RE: Westgate Community Center Phase II
10001 De Vargas Road SW 87121
Grading and Drainage Plan
Engineer's Stamp Date: 12/22/2022
Hydrology File: M09D030

Based upon the information provided in your submittal received 12/22/2022, the Grading & Drainage Plan is approved for Building Permit approval. Please attach a copy of this approved plan in the construction sets for Building Permit processing along with a copy of this letter.

RE: Westgate Community Center Phase II
10001 De Vargas Road SW 87121
Grading and Drainage Plan
Engineer's Stamp Date: 10/21/2022
Hydrology File: M09D030

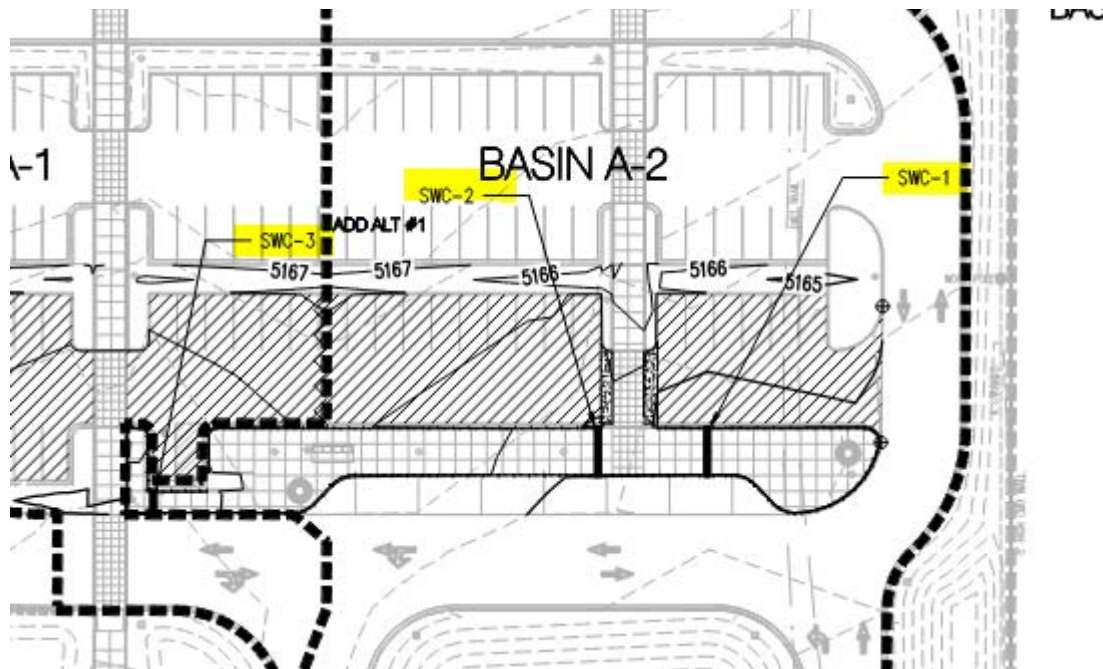
- Sheet C-001: The total numbers (highlighted) for both proposed and existing conditions do not match with the summary of the sub-basins' numbers. Please verify. Has pond 3 already been built? If so, delete "Future" in pond data table. Indicate the sidewalk culverts locations or delete the sidewalk culvert table if they are not a part of this phase.

- The populated quantities for Pond 3's required volume is based on the summation of Basin A-2 which can be seen on sheet C-001 and the overflow volume from Pond 2. Adding these two values together we can see that the total volume required for Pond 3 is equal to $13567 \text{ CF} + (18538 \text{ CF} - 9585 \text{ CF}) = 22520 \text{ CF}$. This total volume required for Pond 3 was previously showing an incorrect value and has been updated to show 22520 CF.
- Pond 3 has in fact already been built so the "Future" located in the Pond Data Table has been removed.
- The sidewalk culvert locations are in fact located on sheet C-001. A snip of the referenced locations has been shown below for clarification.

FEMA MAP: 35001C0336H

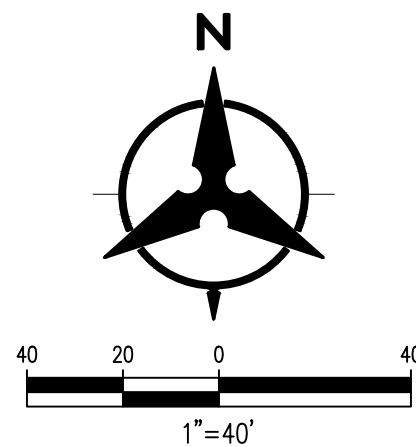
- Please provide the FEMA FIRM map and the vicinity map showing the location of the site.
 - *The FEMA FIRM map has been added to sheet C-001 and a hatched area detailing the exact project location has been called out on the map as well.*
